NOTES AND ERRATA

POWER PLUG
(LOOKING AT SCREWS)

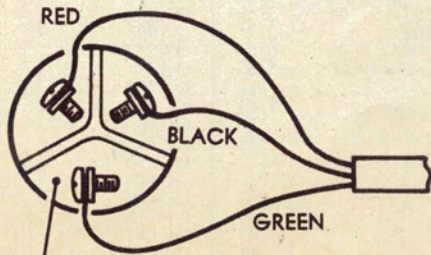
LOW COST STEREO SYSTEM: (January 1972, File No 1 / SA / 38). Several readers have commented on the diagram on page 39, querying the connection of the

active and neutral leads to the three pin plug. Contrary to what some readers apparently believe, there is strictly no regulation requiring that the active, neutral, or earthing conductors be connected to a plug or socket in any specific order. All that exists is a recommendation that the pins be wired in the order earth, active, neutral, in a clockwise direction, when viewed from the front of the socket. In practice, this convention will have been followed in the vast majority of installations. Since the wiring we showed does not conform to it, the black and red leads should be transposed, as shown.
